Public Service
Company of Colorado

February 2, 1988
Fort St. Vrain
Unit No. 1
P-88045

SUBJECT: Technical Specification
Upgrade Program (TSUP)
Additional Information

RESPONSE TO NRC
REQUEST FOR ADDITIONAL INFORMATION
PROVIDED IN ENCLOSURE 2
TO G-87217

Fig. 3.0-1. FSV Decay Heat Power Fraction vs Time after Reactor Shutdown for Various Times at Constant Power

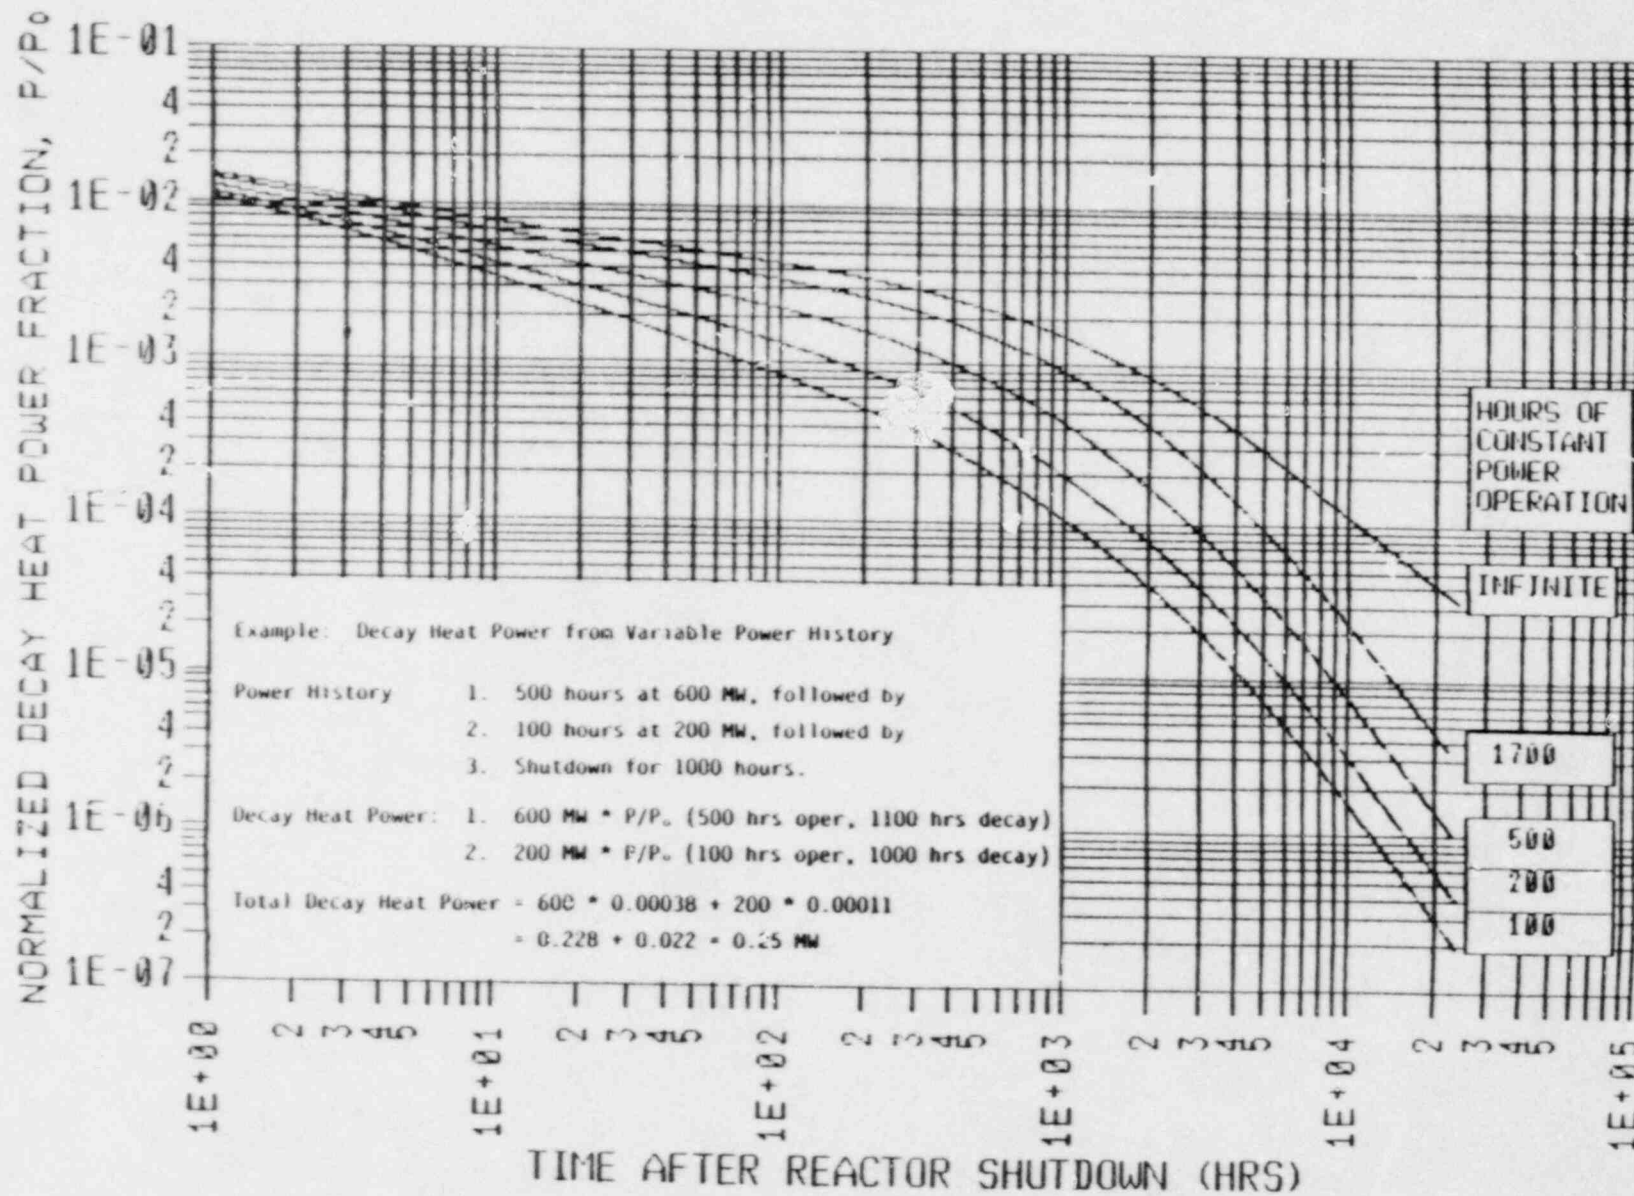
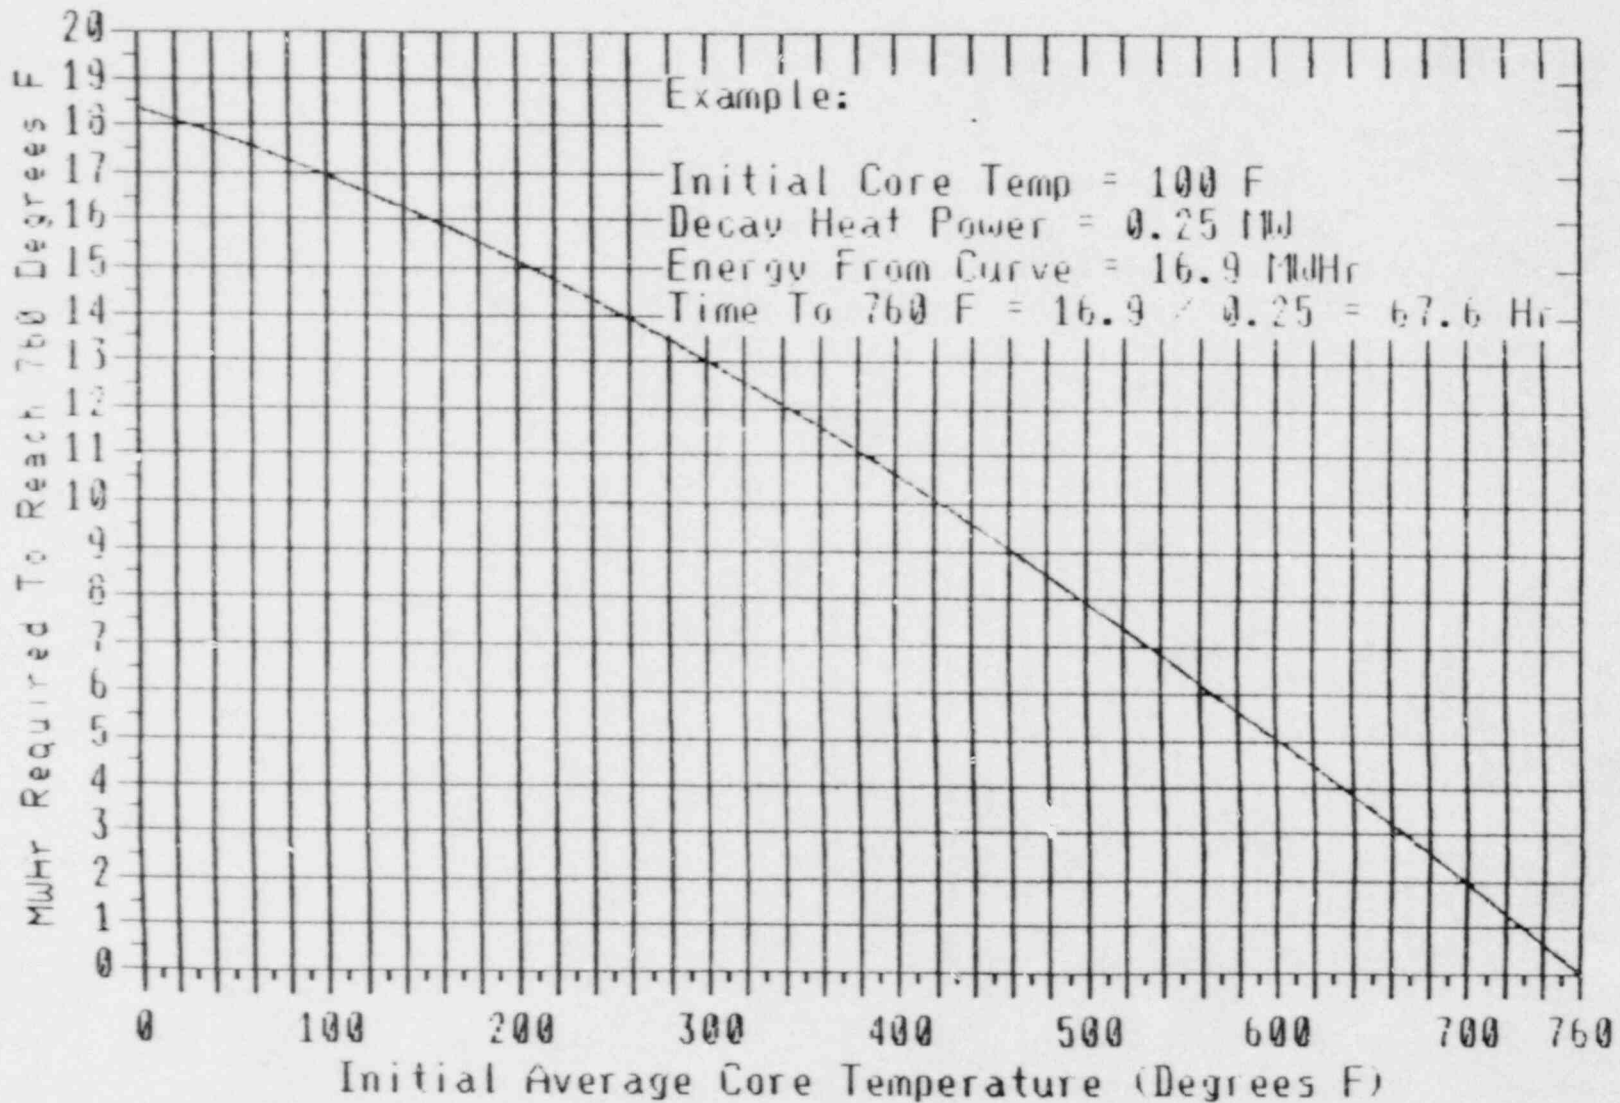
Please provide an equivalent LCO to the recently proposed LCO 4.0.4 in the existing Technical Specifications.

This comment addresses the guidance regarding use of the Calculated Bulk Core Temperature. PSC agreed to include the identical information as new Specification 3.0.5.

- a. Using the applicable operating power history prior to interruption of primary coolant flow, determine the decay heat power from Figure 3.0-1.
 - b. Using this decay heat power and the average core temperature prior to the primary coolant flow interruption, determine the time required to reach 760 degrees F from Figure 3.0-2.
